## Memorandum:

Recommendation for Termination of Contract #23300 –  
Brentwood Concrete Panel Replacement Street Repair

### Exhibit 2:

Text Conversations Between CA and  
Contractor

**CONCRETE STREET INTERSECTION LAYOUT**

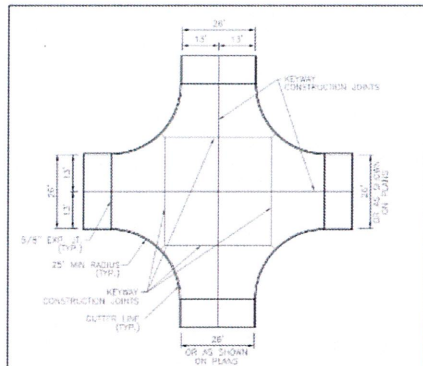
Expansion at the PT

See, I wasn't just trying to nit pick you LOL

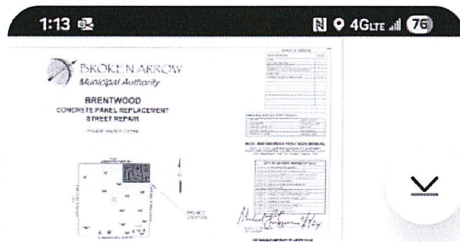
Only expansion in all of these plans is in driveways and sidewalks

Look at General Note 1

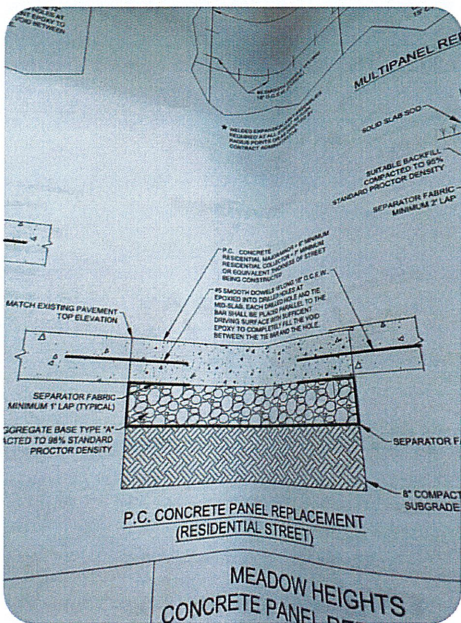
I get that but if they have a different detail they have to add that to the plans can't switch details and design

What detail is different? The detail you sent is the detail for dowels/layout along a strait stretch. The detail in the spec book deals specifically for an intersection. Nothing was switched.

No that show what a multi panel look like against existing shows no expansion

Nor does this detail
